Re: Site Plan Application – Design Brief
3700 Twin Falls

Urban Design Brief

Design Directives

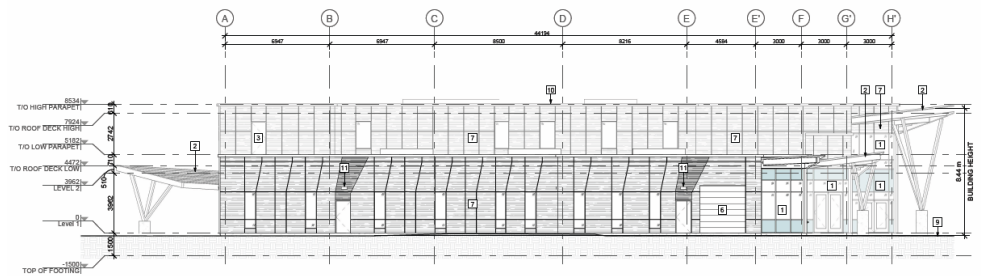
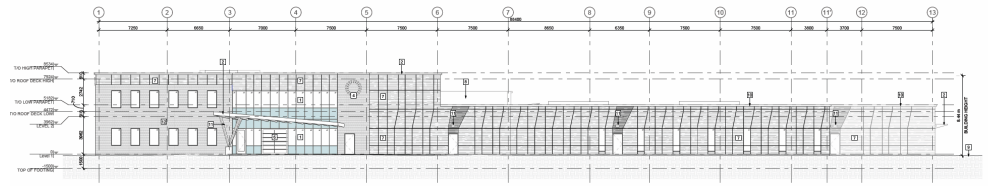
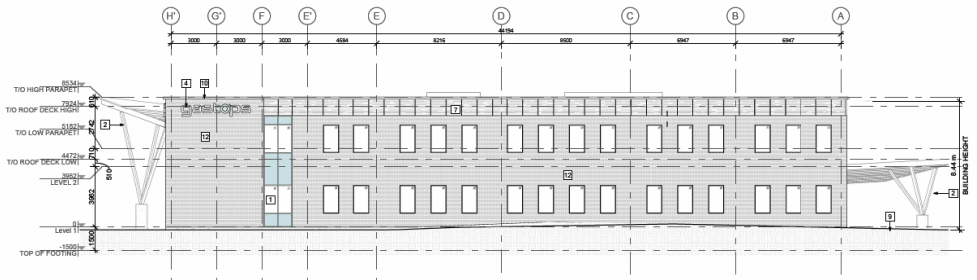
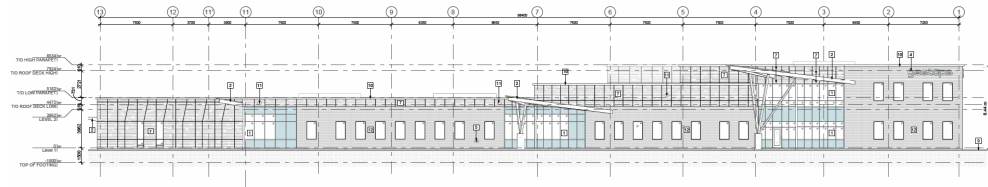
11. Please include architectural treatments and features at the northeast corner of the building (viewable from Limebank and Leitrim). Even though it is not the main entrance corner, the building should have a strong street presence.

12. For the façade facing Limebank, please include windows when possible. Where blank facades cannot be avoided, utilize landscape elements to break up the building wall.

CSV Response: Future building expansion phase has accommodated for this. At this time landscaping will be incorporated into this area of the site.

CSV Response: The area along Limebank encompasses an outdoor staff amenity area. Landscaping will be increased in this area, in addition the design includes for maximum amount of windows without comprising security of the building into the manufacturing areas.
